S650.md 2022/9/27

相机动画调整:

Camera adjustment & animation

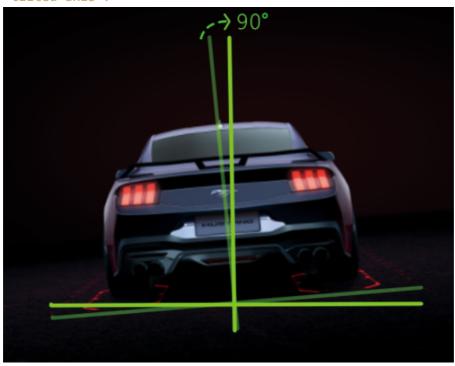
1. 允许相机与头像交互

The cameras have been modified to allow for user interaction with the avatar.

'头像'交互指得是否如下图所示吗?

Was 'avatar interaction'represent below sketch map?

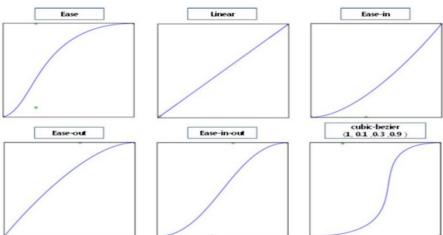
4. 一些过度存在相机抖动,需要修改为平滑过度,特别是从排气模式过渡到悬架模式,从自动模式到牵引模式。

Some cameras jolt into place, all transitions need to be smooth. Noticed it transition from exhaust to suspension, auto to traction.

是否同意使用如下图所示的: 运动曲线 和 时间方程? Do we agree with motion curve which is straight and timing function be like Ease_in_out just as following sketch map?

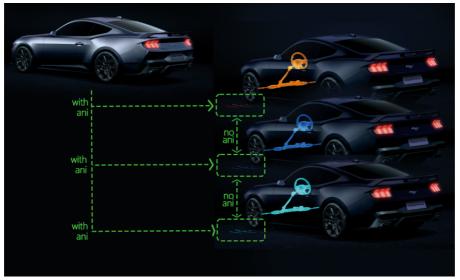
6. 切换某一模式下的属性,地面动画不应当重新加载,重新加载地面动画只出现在基础模式进入某一模式时。(适用于: Steering, Exhaust, Magne Ride, Autostart, Traction)

Currently, it appears as when any attribute is toggled the ground texture is animating on. Let's keep this isolated to the Base Drive Modes. The textures feel like they are turning off and on when they should appear to be switching. (Steering, Exhaust, Magne Ride, Autostart, Traction)

逻辑是否如下图所示?

for example as the steering module ground animation. Was the following sketch map logic correct?
